Addendum No. 2
August 30, 2024

Project: KOA – Rapid City Office
Rapid City, South Dakota
#3017

Architect: Architecture Incorporated

Scope of this Addendum:

5 SECTION DETAIL
SCALE: 1/2" = 1'-0"

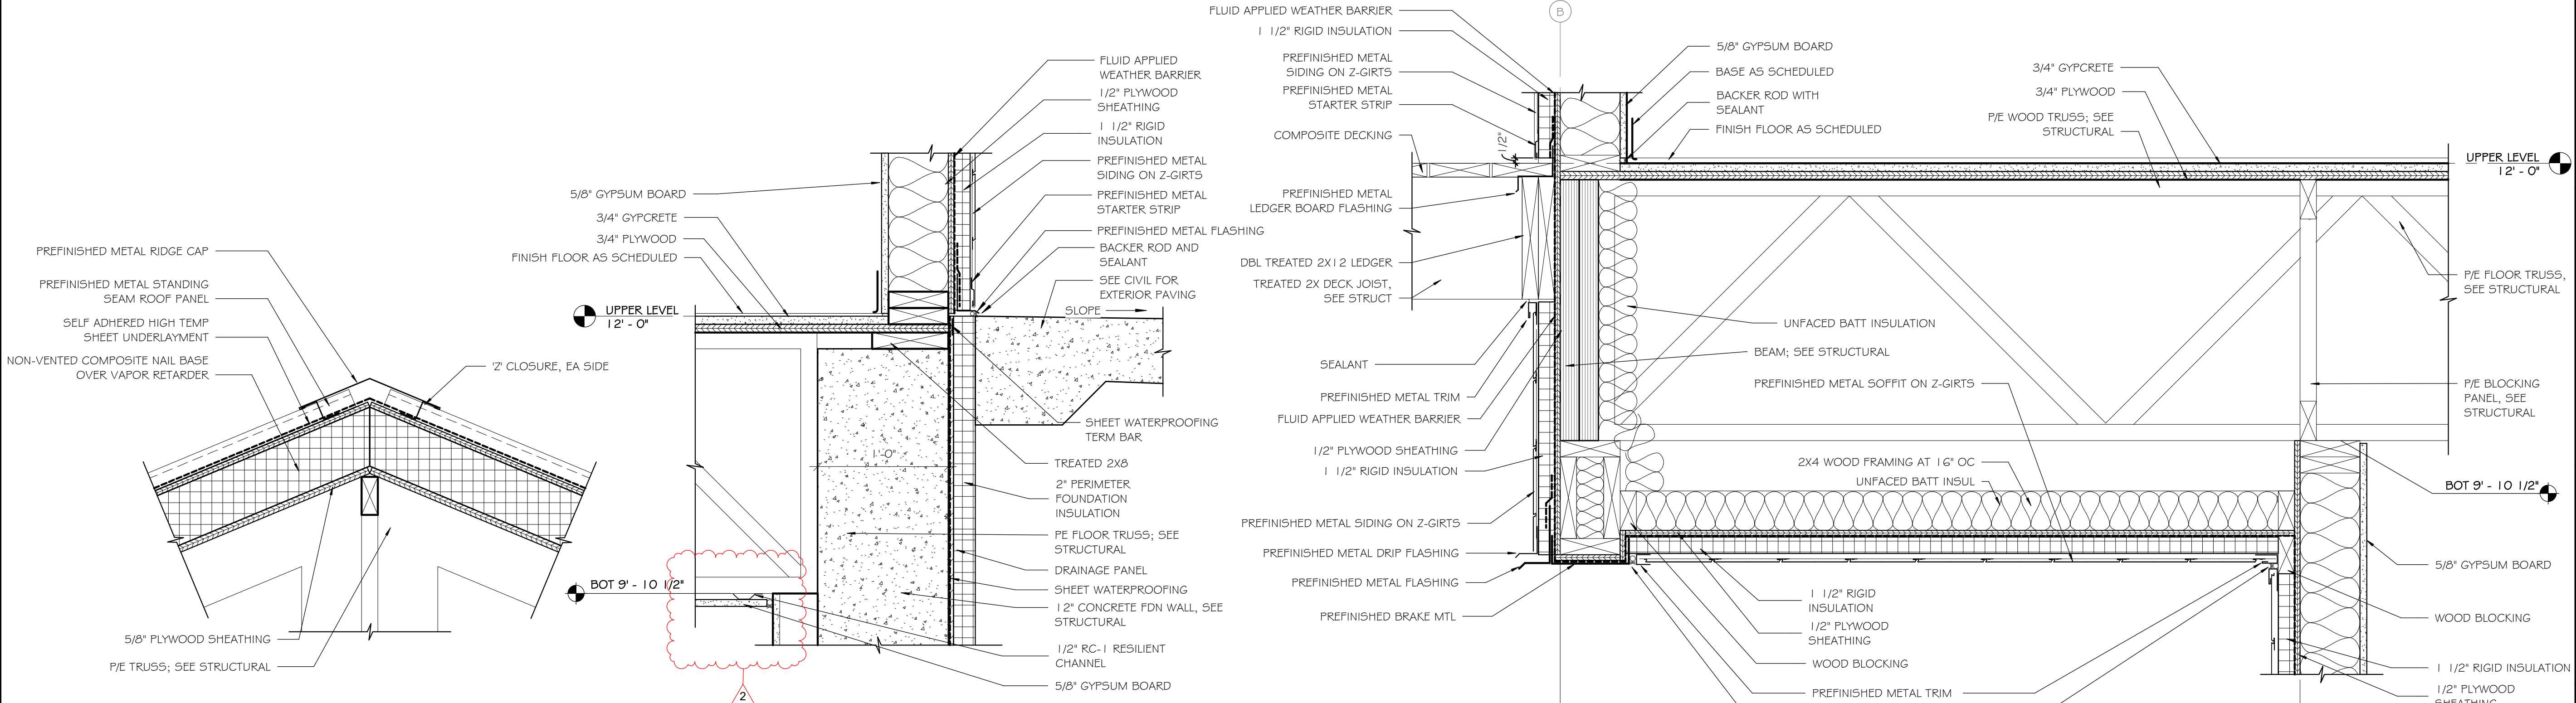
- 2) DRAWING 5.40 SECTION DETAILS
 - a) Revised detail 5/5.40 – Modified ceiling detail to be single layer of 5/8” gypsum board over 1/2” resilient channel.
 - b) Revised sheet 5.40 is attached, with changes clouded and noted as “2”.

5 SECTION DETAIL
SCALE: 1/2" = 1'-0"

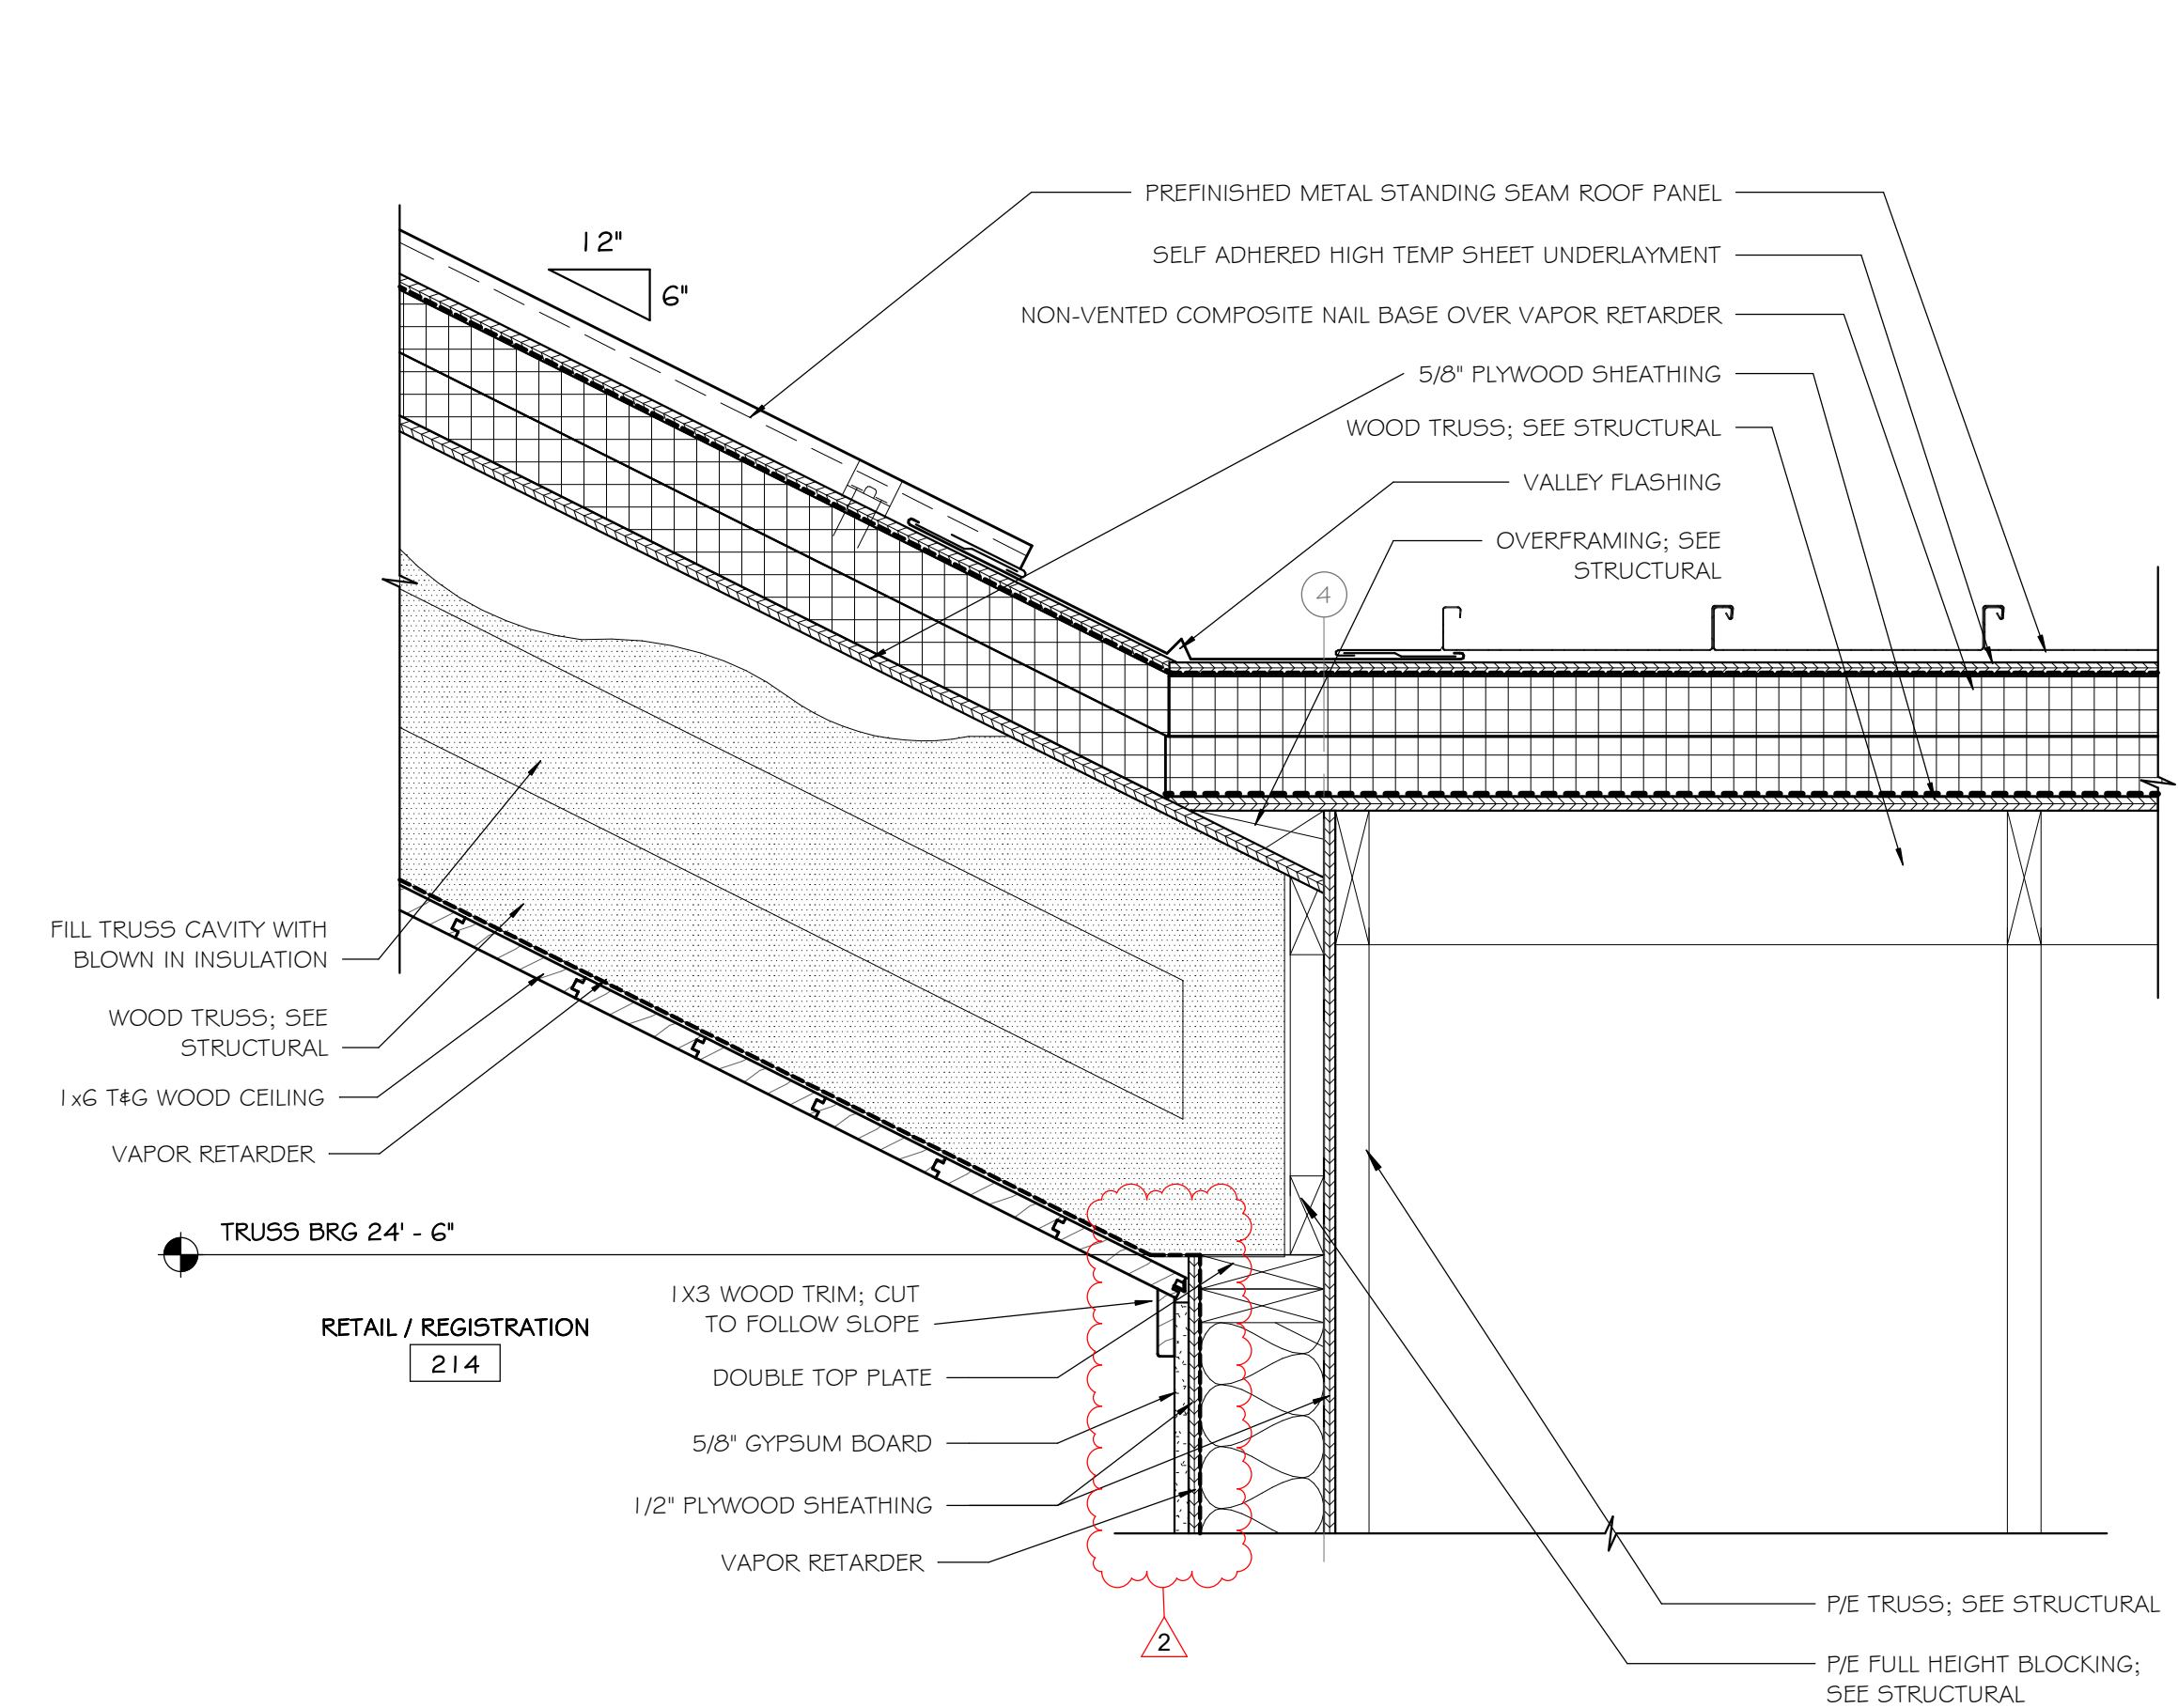
- 3) DRAWING 5.42 – SECTION DETAILS
 - a) Revised detail 3/5.42 – Deleted second layer of 5/8” gypsum board from detail to align with wall type indicated on floor plan.
 - b) Revised detail 5/5.42 – Deleted second layer of 5/8” gypsum board from detail to align with wall type indicated on floor plan.
 - c) Revised sheet 5.42 is attached, with changes clouded and noted as “2”.

2.30

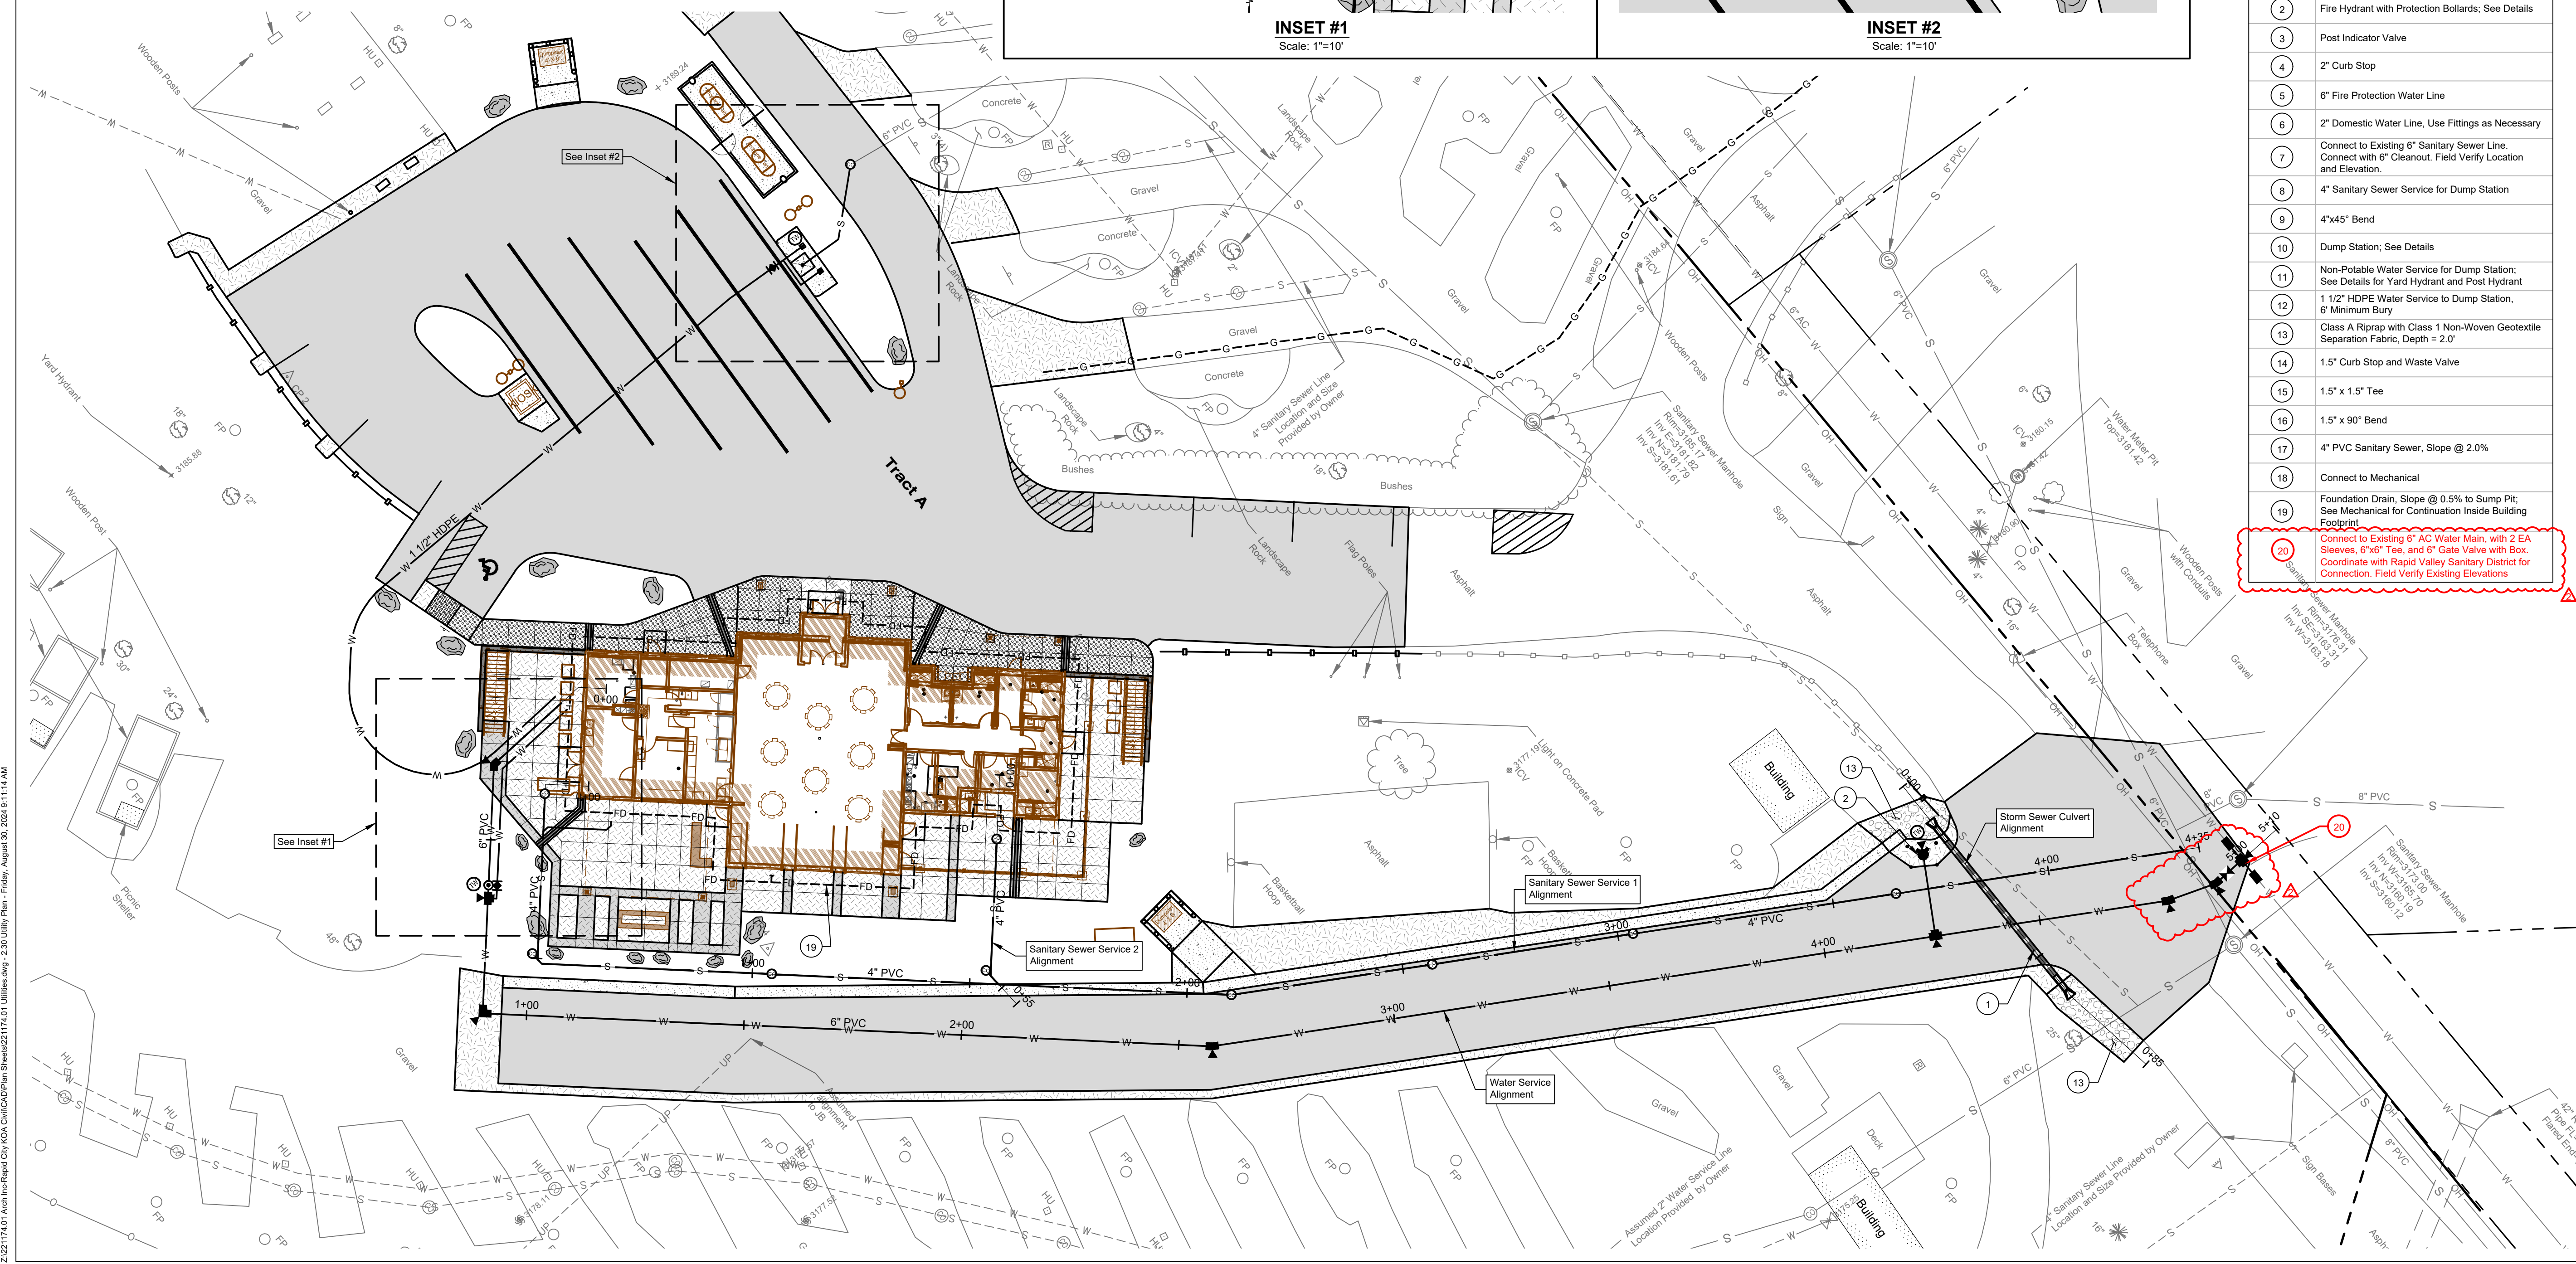
<u>Item</u> C2-1	<u>Description</u> SHEET 2.10 Phased Demolition for Building Foundation and Wall Construction
	The Contractor will be allowed to demo additional asphalt pavement between the Existing Registration Building and the Restroom/Showers building to construct the proposed building foundation and walls. The Contractor will be able to close the main access drive from November 1 st , 2024 to March 15 th , 2025 to complete this work. Contractor to provide temporary gravel surfacing and maintain surfacing where asphalt within phase 2 demo has been removed.
<u>Item</u> C2-2	<u>Description</u> SHEET 2.10 Temporary Construction Fencing
	Orange plastic temporary construction fencing is an acceptable material for temporary fencing shown on the Demolition Plan. Contractor may use other material type of fencing as required for their own purposes during construction.
<u>Item</u> C2-3	<u>Description</u> SHEET 2.30 and 2.31 – Utility Plan & Profiles (Sheet Revision) Changes to the Water Service Line Connection Point

See revised drawings for changes to the water service line connection to the existing water main. has been changed. See
<u>Item</u> C2-4	<u>Description</u> SHEET 2.41 – Enlarged Grading Plan (Sheet Revision) Changes to the Spot elevations
	See revised drawings for changes to spot elevation along proposed wall and sidewalk.
<u>Item</u> C2-5	<u>Description</u> SHEET 2.75 – Details (Sheet Revision) Changes to the Details
	See revised drawings for changes to the following details:

8" GRAVEL SURFACING
Not To Scale

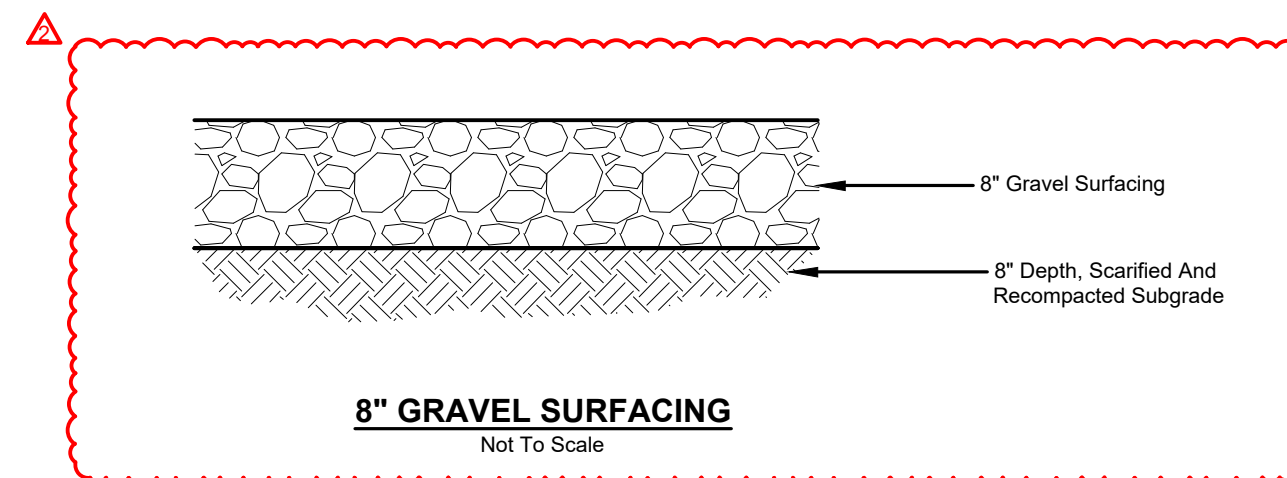
- Typical Foundation Drain Detail
- Thickened Edge Sidewalk
- Reinforced Concrete Sidewalk
- 8" Gravel Surfacing
